8.10. Planning Proposal 1/21 - 270-272 Pacific Highway, Crows Nest

To present an assessment report for Planning Proposal No. 1/21 at 270-272 Pacific Highway, Crows Nest after its consideration by the Local Planning Panel on 29 September 2021.

Figure 18. Eastern elevation of concept scheme (Source: fitzpatrick + partners 2021).

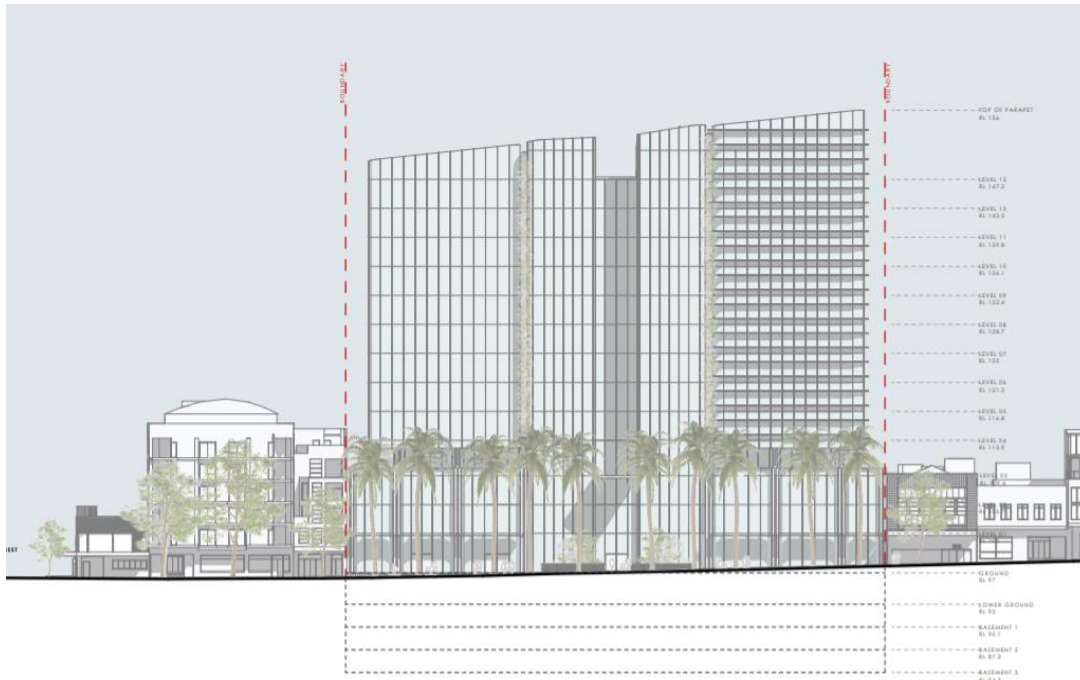
The concept scheme shows a building with a height of up to RL156 (59m) at its highest point, with the building reducing in height towards the south and west (figure. 18). The scheme shows somewhat typical floor to floor heights for a commercial tower, with most floors showing a floor-to-floor height of 3.7m. However, the scheme shows the ground level with floor-to-floor heights of 5m, podium plant level with height 4.5m and the upper rooftop plant level showing a height of approximately 8.8m.

The ground level and mid-plant floor-to-floor heights are relatively common and not considered to be an issue. With respect to the roof plant level, it is considered that a height of 8.8m is excessive, ultimately resulting in a building higher than what would be expected for a 13-storey commercial tower.

For the reasons outlined in this report, it is recommended that Council support the progression of the Planning Proposal to the DPIE seeking a Gateway Determination, noting a reduction in height from 59m to 54m and the recommendation for site-specific DCP provisions to be prepared to help guide future detailed design and development application assessment process.

Figure 20 - Building relationship as viewed from the south (Source: fitzpatrick + partners 2021).

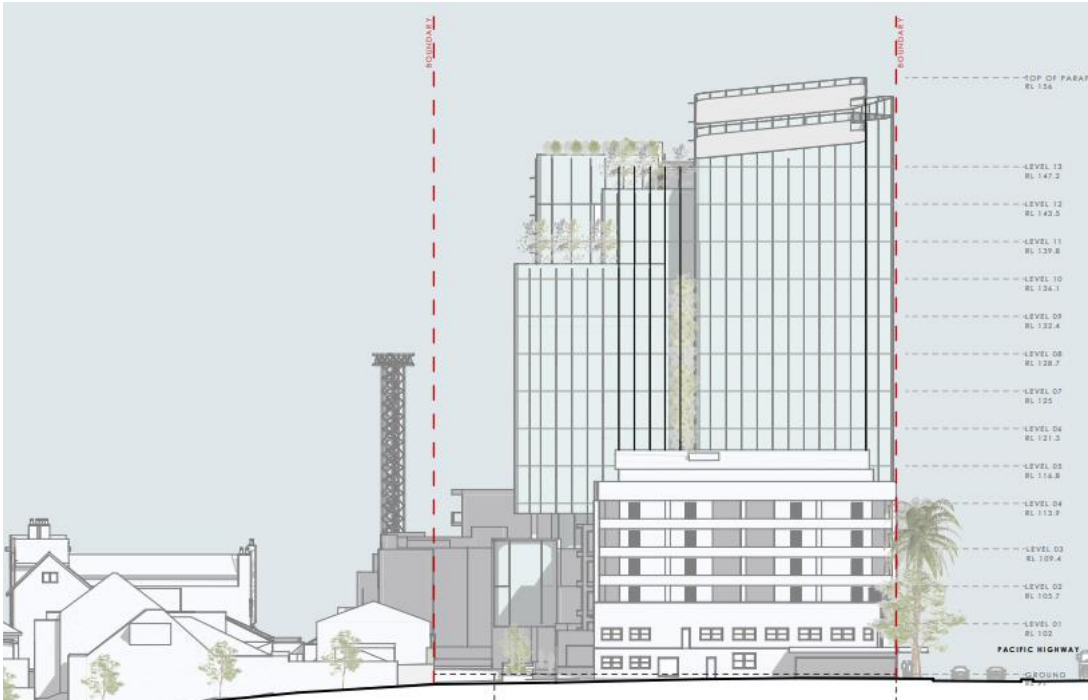
The Plan includes the 'transition and interfaces' principle, which makes references to the fact that height transitions should be sought for development adjacent to lower scale areas. The concept design included with the proposal shows a 'stepping' of the built form at higher levels. The applicant has provided the following comment on the building transition, with such transition shown in the proposed setbacks in figures 19 and 20.

Whilst it is observed that the interface or physical spatial relationship between the existing low density residential and that proposed is dramatic, this is difficult to entirely avoid considering the vast difference in allowable heights between the sites as stipulated under the 2036 Plan. The Pacific Highway is identified as a major development corridor in the area, with other sites along Pacific Highway earmarked to present comparable transitions and interfaces to what is proposed. In light of the proposal being compliant with the building envelopes envisaged by the 2036 Plan and considering the future heights and density identified along the corridor and throughout the precinct, the proposed building transition or interface to the rear in this instance is considered to be acceptable in this context.
